Access Compliance Report

Public Rights-of-Way

(Curb Ramps)

Intersection ID: 45761	Main Street: SOLACE_CT	Cross Street: GRANDEUR_RD	Location: NW
ADA ID: 7767F3C289B0	Ramp Type: Perp	Initial Pass/Fail: Fail	Overall Compliance: No
Codes/Mitigation Info/Possible Solution			Severity Score: 25
			Field Measurements/Component Compliance

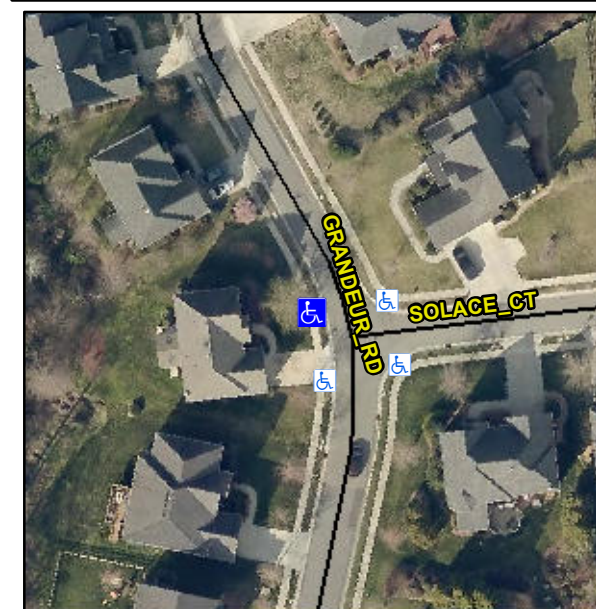
Not Found, R304.2.2, R304.5.3

Compliance	Description	Data	Compliance	Description	Data
N/A	Ramp Length (in)	47.0	No	Ramp Slope (%)	10.3
Yes	Ramp Width (in)	48.0	No	Ramp XSlope (%)	5.3
N/A	Flare Type LT	N/A	N/A	Flare Type RT	N/A
N/A	Flare Slope LT (%)	N/A	N/A	Flare Slope RT (%)	N/A
N/A	Flare Traversable LT?	N/A	N/A	Flare Traversable RT?	N/A
N/A	Landing Length (in)	N/A	N/A	DWS Provided?	N/A
N/A	Landing Width (in)	N/A	N/A	DWS Contrast?	N/A
N/A	Landing Slope (%)	N/A	N/A	DWS Length (in)	N/A
N/A	Landing X Slope (%)	N/A	N/A	DWS Full Width?	N/A
N/A	Landing Curb? (Y/N)	N/A	N/A	DWS Offset (in)	N/A
N/A	Shared Landing?	N/A			
N/A	Gutter Ponding?	N/A	N/A	Gutter Slope (%)	N/A
N/A	Gutter Lip Ht (in)	N/A	N/A	Gutter X Slope (%)	N/A
N/A	Painted X Walk1?	No	N/A	Painted X Walk2?	N/A
	X Walk 1 Direction	To E		X Walk 2 Direction	N/A
N/A	X Walk 1 Width (in)	N/A	N/A	X Walk 2 Width (in)	N/A
	X Walk 1 Slope (%)	6.6		X Walk 2 Slope (%)	N/A
	X Walk 1 X Slope (%)	4.9		X Walk 2 X Slope (%)	N/A

Remove & Replace Entire Ramp.
